Environmental Review Team Report

Pondbrook Subdivision

Westbrook Connecticut

February 1979

Preliminary Subdivision Plan

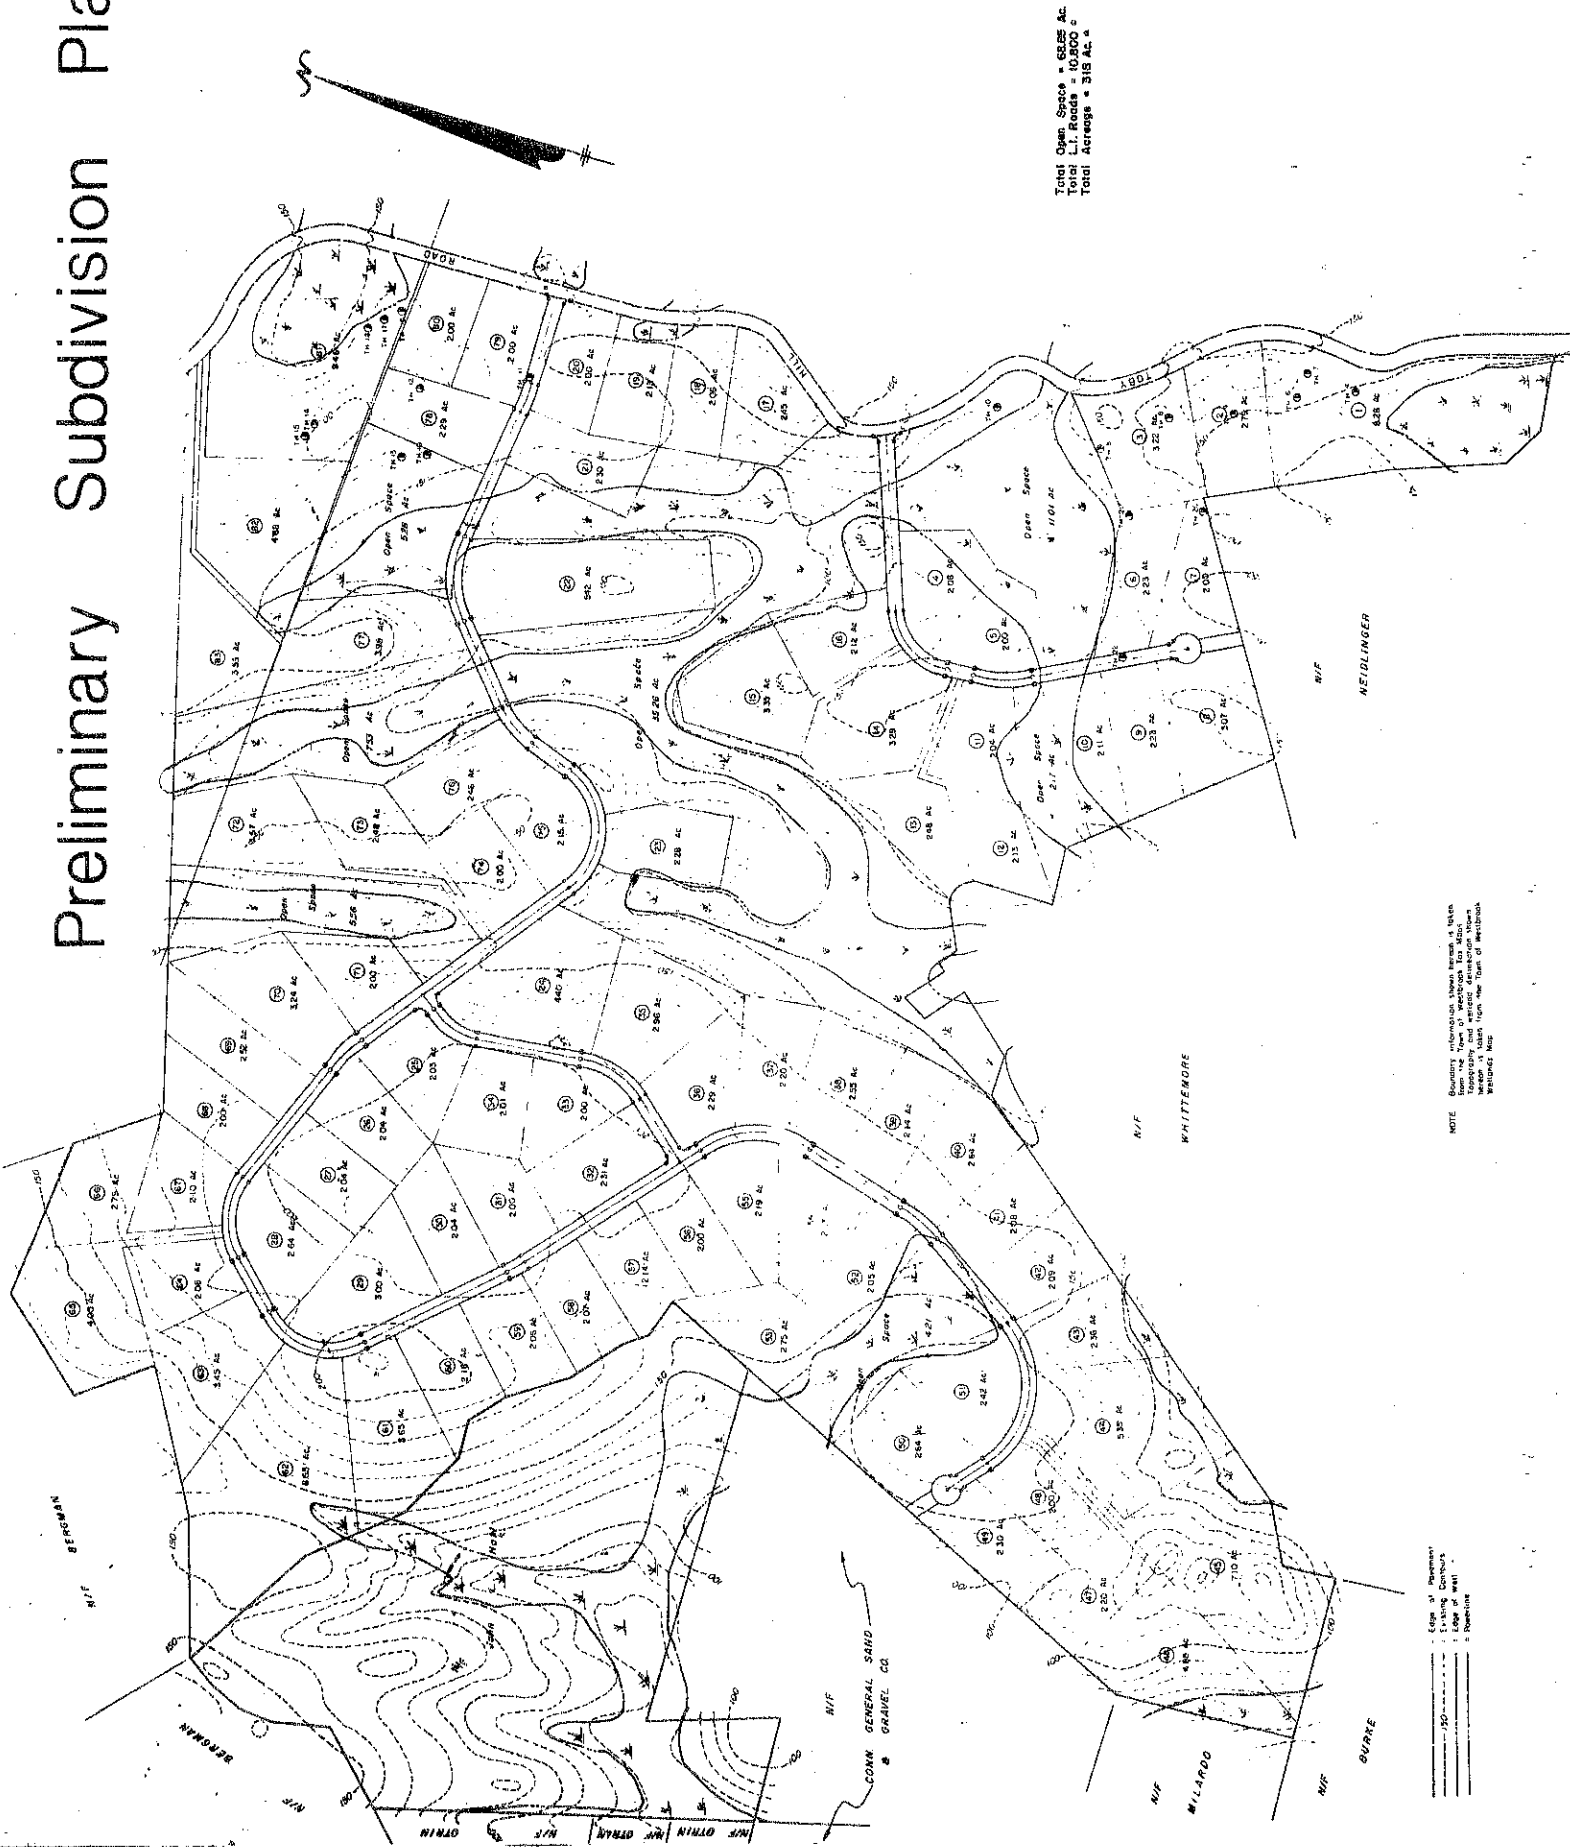
After examination of preliminary soils and topography information and field review of the site, it seems obvious that the density of development proposed is unrealistic. Locations for 80 septic systems will be extremely difficult to find due to the shallow-to-bedrock soils, slope, and wetlands present on this site. Road construction, as proposed on the preliminary plans, will require massive cuts and fills which may be prohibitively expensive. Construction of these roads

in conjunction with their associated wetland crossings will require extensive sediment and erosion control measures to be implemented and maintained. A potential for stream pollution from salts, sands and oils on these roads exists. Storm water management is also a serious concern; a management plan should be developed for this site. Topography should be verified by an actual survey as it appears much steeper in the field than is actually shown on the preliminary plans.

Given the site constraints and the density of development proposed, a distinct potential for ground water pollution exists (See sections on Water Supply and Waste Disposal). It would be prudent to develop preliminary plans for subdivision of this site around a detailed survey of areas found acceptable for establishment of sewage disposal systems. It appears that specially engineered systems would be needed in even these instances.

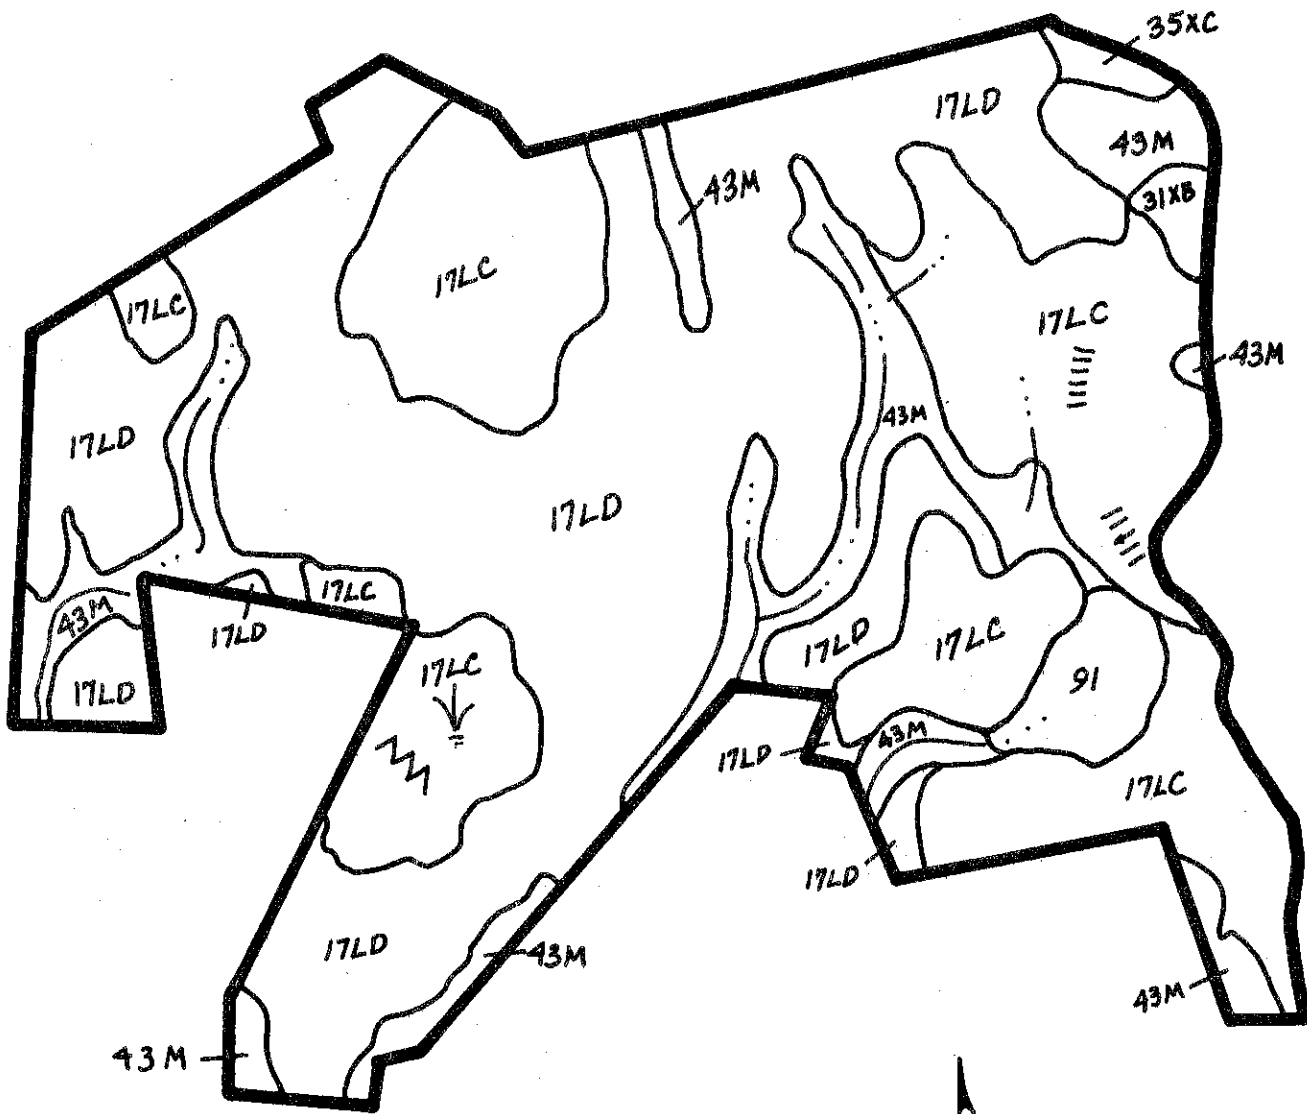
The proposed roads for "Pondbrook" have only one exit and entrance onto Toby Hill Road. Although a second exit is proposed on the west side of the subdivision, connecting it to East Pond Meadow Road, the possibility of completing this alternative access/egress is minimal given the land ownership and use patterns in that area. With that in mind, a loop road system connecting to Toby Hill Road should be planned rather than the presently proposed dead-end roads.
